DOCUMENT 00901
ADDENDUM NO 1

DATE: January 29, 2026

PROJECT NAME: River Bend Transit Facility Addition

Project: River Bend Transit – Bus Storage Facility

M4

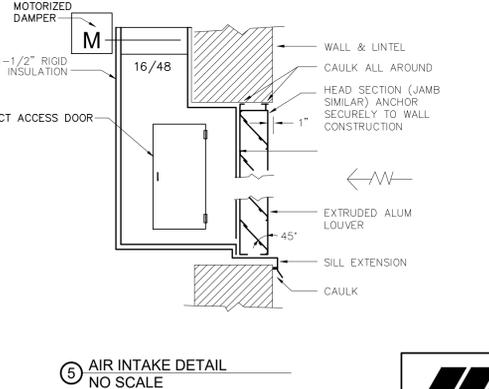
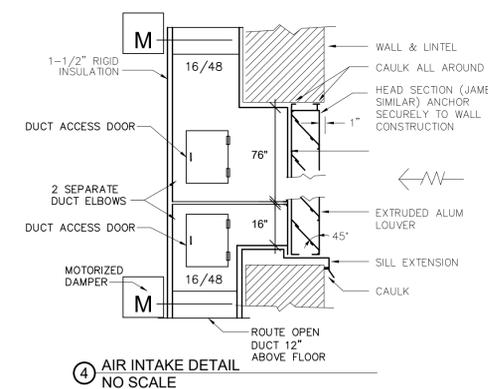
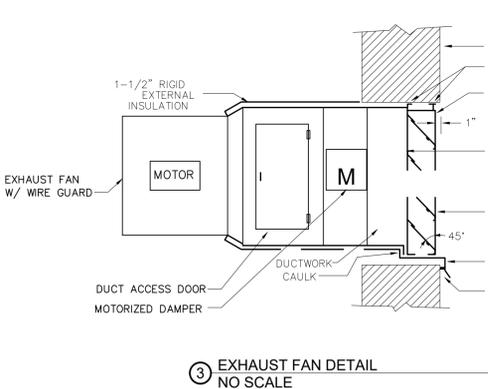
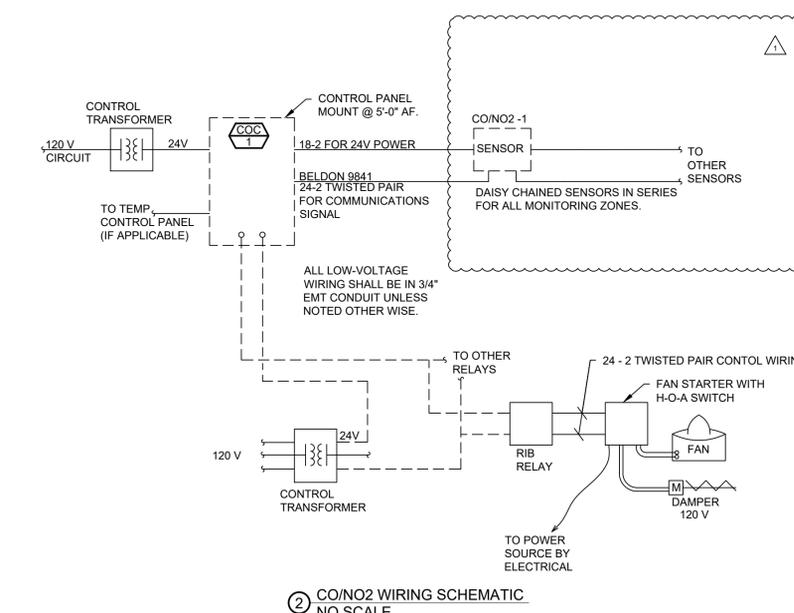
1. Sheet M3: Replace sheet in its entirety with revised sheet. Provide remote-mounted thermostat for each unit heater. Provide combination CO/NO2 sensors in lieu of separate CO and NO2 sensors.
2. Sheet M4: Replace sheet in its entirety with revised sheet. Replace Gas-Fired Unit Heater Schedule and CO and NO2 Monitoring Equipment Schedule. The CO and NO2 Monitoring Equipment manufacturer was changed to Marcurco and combination sensors.

- PROVIDE REMOTE-MOUNTED HEATING THERMOSTAT WITH SWITCHING SUB-BASE, POWER VENTING WITH CLASS B VENTING
- PROVIDE BABAA-COMPLIANT EQUIPMENT WITH BABAA DOCUMENTATION.
